MEMORANDUM

SUBJECT: Additional Information – REV2023/011 – 143 -145 Riverview Road, Avalon Beach

The purpose of this memo is to provide a response to the Panel in relation additional information provided to Council from the Applicant. The information is in response to the DDP's request for clarification in relation to the works within the foreshore area.

Image 1 – Proposed waterway access stairs

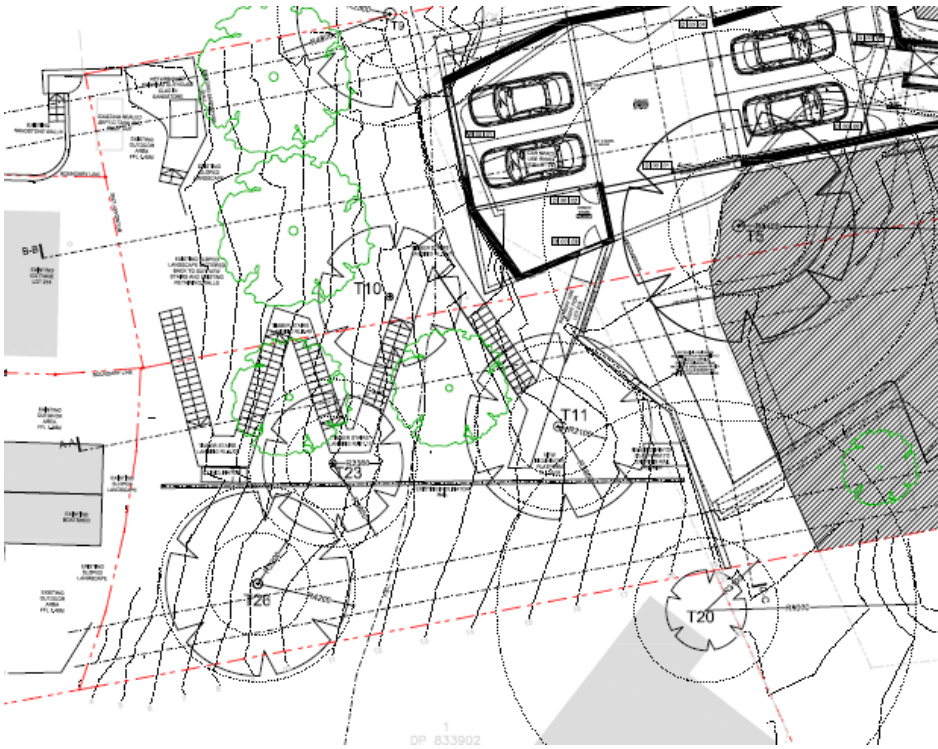
The proposed development includes a waterway access stair. No other works are proposed in the foreshore area.

The proposed development is consistent with the objectives of the C4 Environmental zone. The appearance of the proposed development is compatible with the surrounding area. The proposed stairs will not cause environmental harm in relation to pollution, siltation, surrounding uses,

marine habitat, wetland areas, flora or fauna habitats, drainage patterns or remnant riparian vegetation. The proposed stairs will not cause congestion or generate conflict between people using the adjacent open space or waterway. The proposed stairs retains public access along the foreshore. The proposed development will not result in adverse impacts to any historic, scientific, cultural, social, archaeological, architectural, natural or aesthetic significance of the land. The proposed stairs will not have an adverse impact on the amenity or aesthetic appearance of the foreshore. The proposed development will not impact upon sea level rise, coastal erosion or recession, or change flooding patterns.

The proposed development will retain continuous public access to and along the foreshore. The proposed development does not impact upon any public access. The proposed development is acceptable in relation to the foreshore character and the existing environmental conditions.

The applicant has satisfied the Panels query in relation to extent of works in the foreshore area. The works proposed within the foreshore area are limited to the water-way access stair detailed in the architectural and landscape plan. Condition 1 and Condition 41 are recommended to be amended to ensure that if consent is granted for this application, the conditions relate to the amended set of plans.
